# UNITED STATES PATENT AND TRADEMARK OFFICE

APPLICATION NO.	FILING DATE	FIRST NAMED INVENTOR	ATTORNEY DOCKET NO.	CONFIRMATION NO.
09/923,611	08/07/2001	Frank Cornelis Penning	NL000452	1413
24737	7590	11/16/2004	EXAMINER	
PHILIPS INTELLECTUAL PROPERTY & STANDARDS P.O. BOX 3001 BRIARCLIFF MANOR, NY 10510			CHEN, TIANJIE	
			ART UNIT	PAPER NUMBER
			2652

### ***2<sup>nd</sup> Non-Final Rejection***

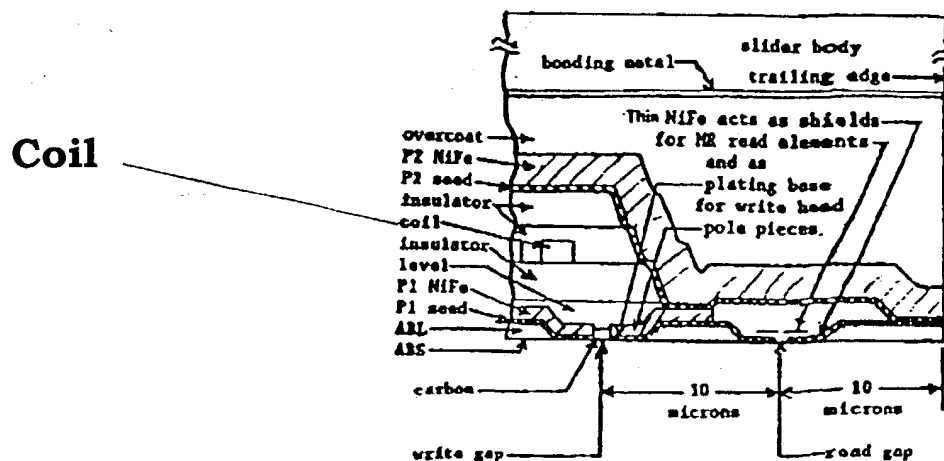
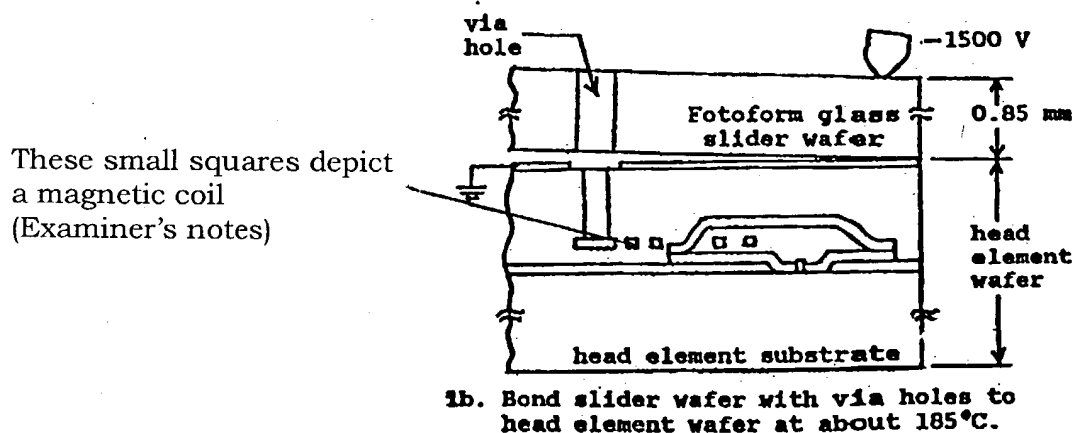
With regard to claims 1, 5, and 13, Chapman shows a method of manufacturing a magnetic head having a head face/a slider and having an air bearing surface (ABL in Fig. 1a) including small squares which extending parallel to the head face, in which method small squares formed at a first side of a first substrate (head element substrate in Figs. 1a-1d), whereafter the first substrate provided with the small squares is adhered (Process Approach Section, lines 10-13) with its first side to a side of a second substrate (Footform glass slider wafer in Figs. 1a-1d), whereafter material of the first substrate (head element substrate) is removed from a second side of the first substrate (Process section, lines 13-15), which second side is turned away from the first side, to form the head face/air bearing face surface (Figs. 1c and 1d, "Process Approach" section, lines 7-16).

Chapman shows small squares in Fig. 1a, which is commonly used in the art to depict a coil but does not specifically pointing out it is a coil.

However, Chapman shows a head element in Fig. 1 with these small squares without indication on what the small squares are. However, Chapman shows in Fig. 1 a head element and shows detailed structure of the head element in Fig. 7, wherein it is explicitly indicated that the small square represents magnetic coil (Enlarged drawing is shown below). One of ordinary skill in the art would have been motivated to recognize that in Chapman's device, a magnetic coil extends parallel to the head face (Introduction, lines 1-4)/ near the air bearing surface.

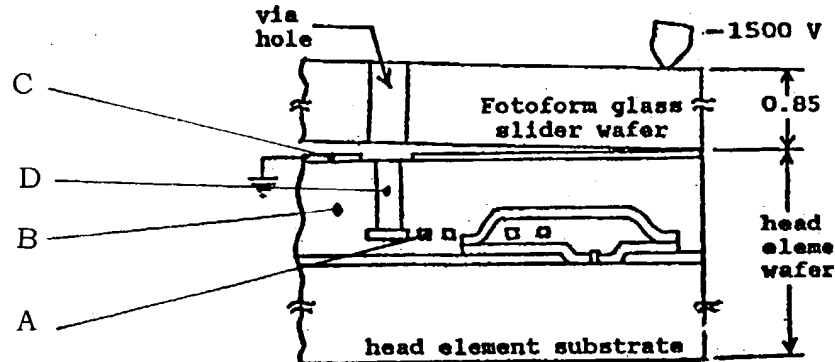
With regard to claim 3, Chapman further shows after a step involving the forming of a layer of a metal A (See the Figures with added numerals attached below) on the first substrate, at least one further step involving the forming of a layer of a non-conducting material B and the forming of a further layer of a metal C and the forming of interconnections D between two neighboring layers C and A of metal is performed to create the magnetic coil.
